1777 WEST 7TH AVENUE (COMPLETE APPLICATION)
DE413828 - ZONE C3-A

DEVELOPMENT PERMIT STAFF COMMITTEE MEMBERS

DEVELOPMENT PERMIT STAFF COMMITTEE RECOMMENDATION: APPROVE

Site Plan
Scale: 1/8" = 1'-0"

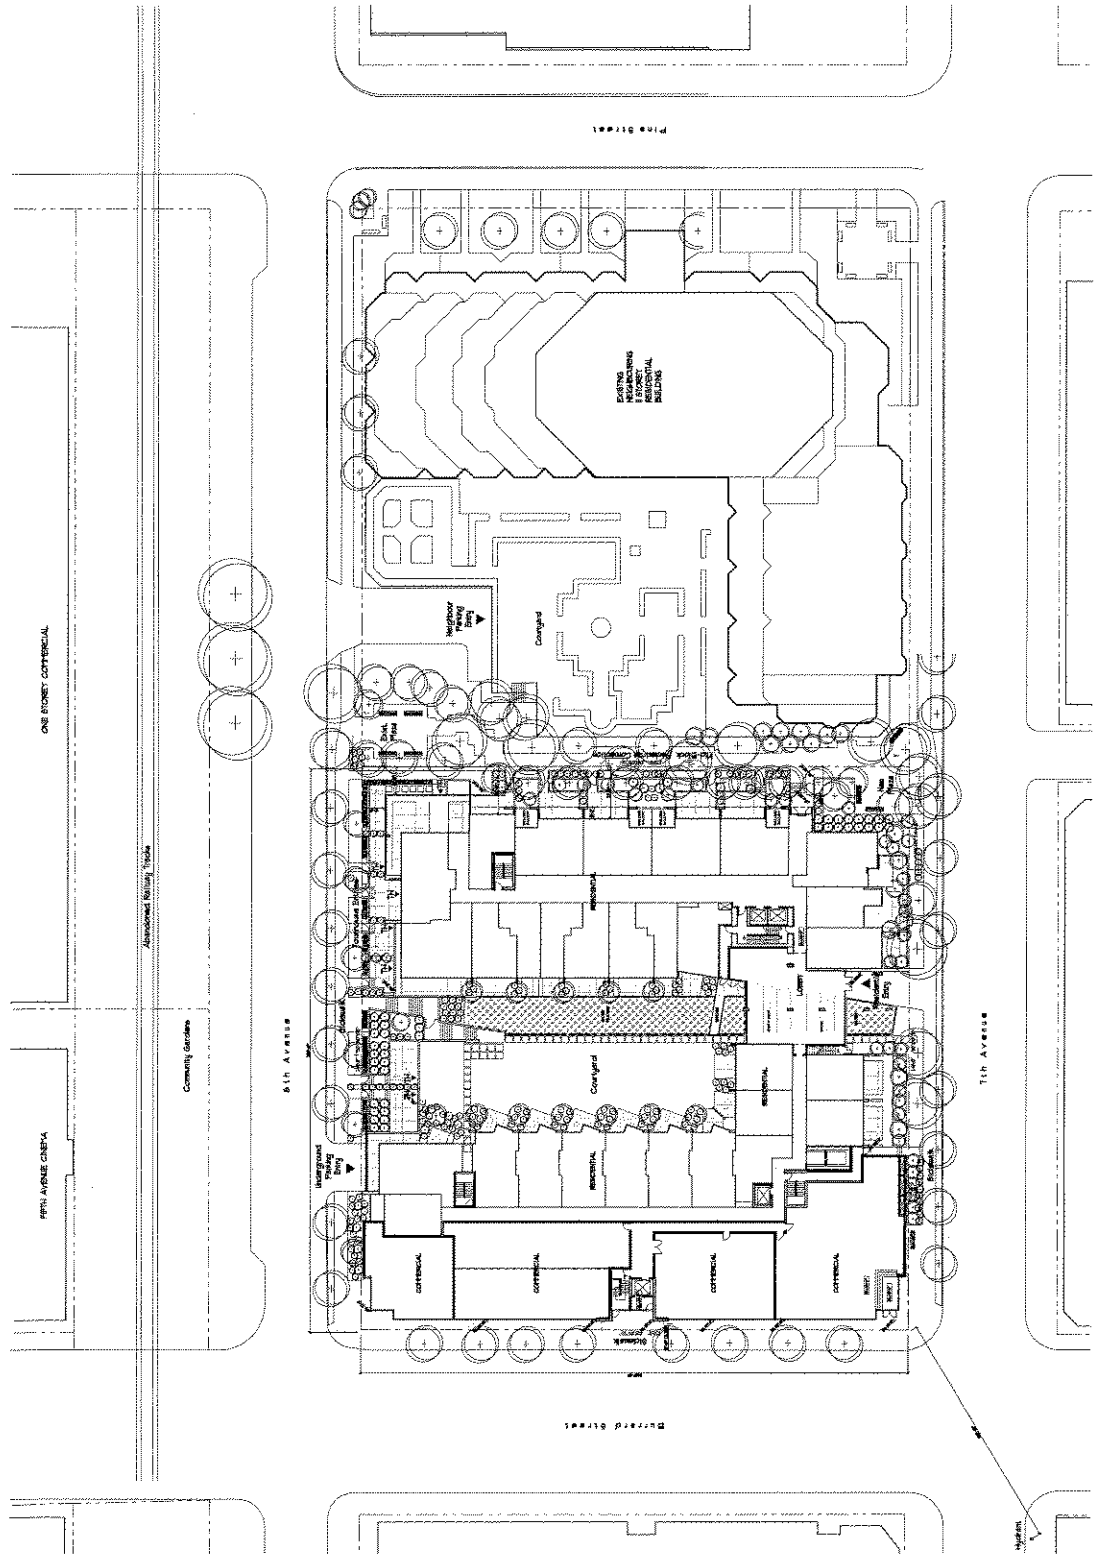
- A.2.1 provide correct legal description on sheet DP1.00;

Note to Applicant: The correct legal description is "Lot A Block 288 District Lot 526 Plan 20938".

DP 2.13
SCALE: 1/8" = 1'-0"

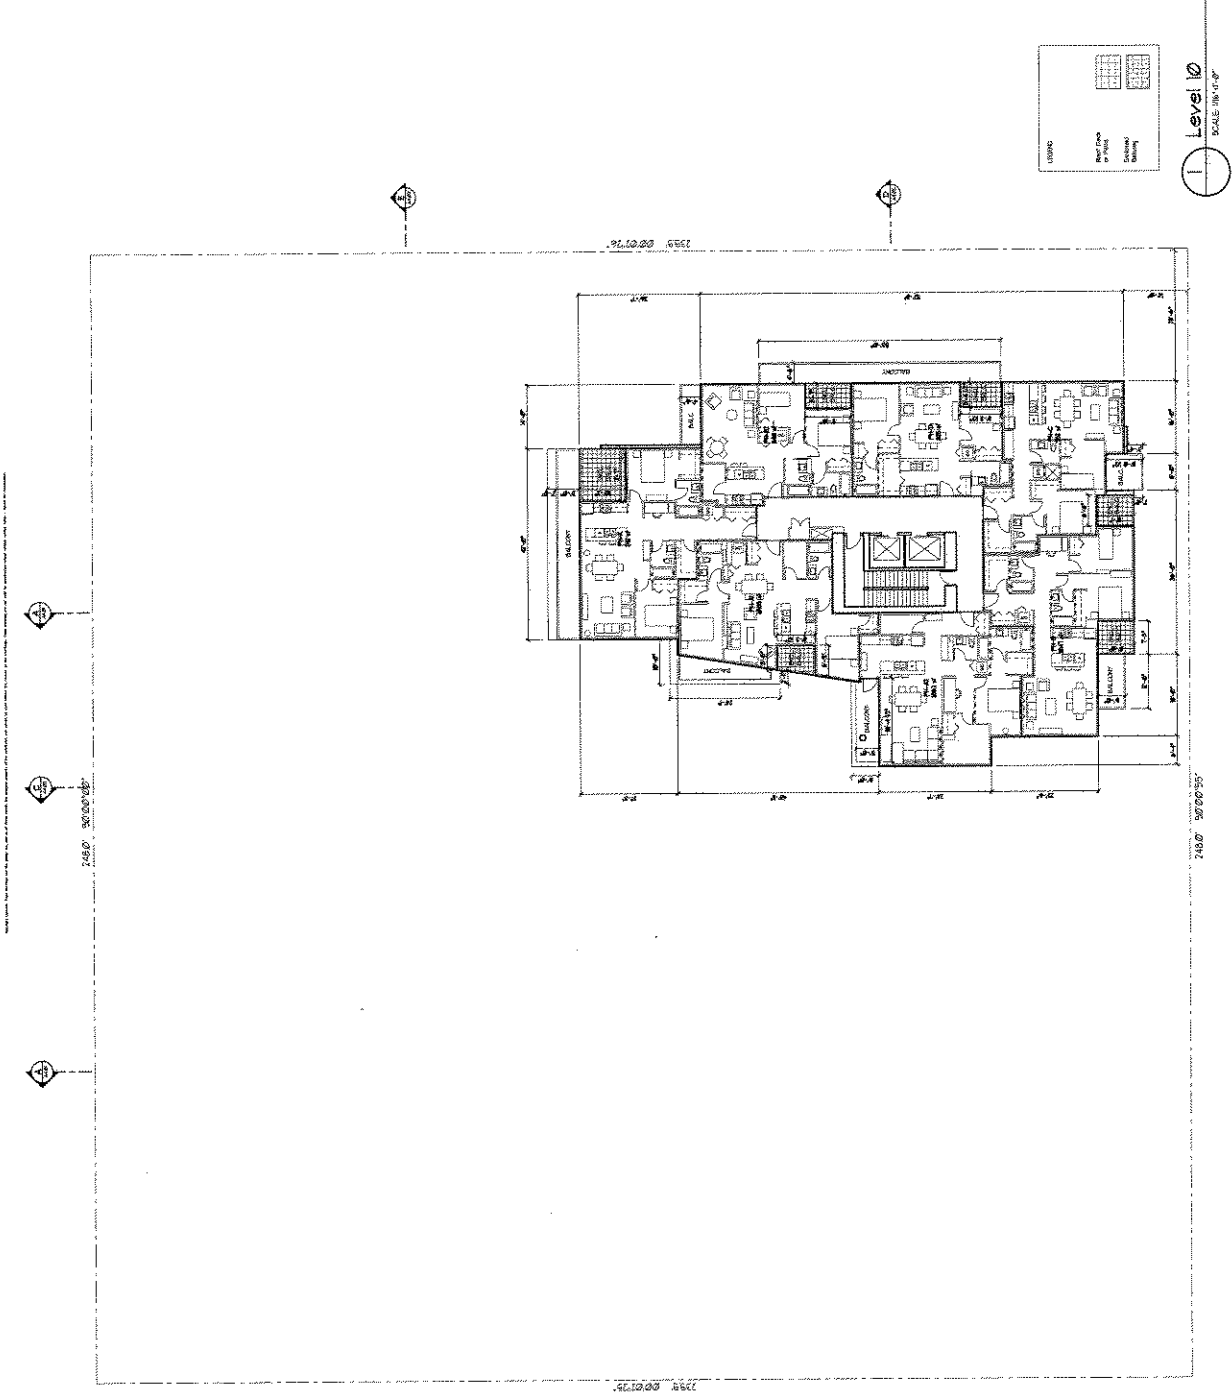
Note to Applicant: Mechanical spaces/equipment located above base surface must be included in the computation of FSR. Show locations of the sections on the roof plan and roof outline (using dashed lines) on level 10 floor plan.
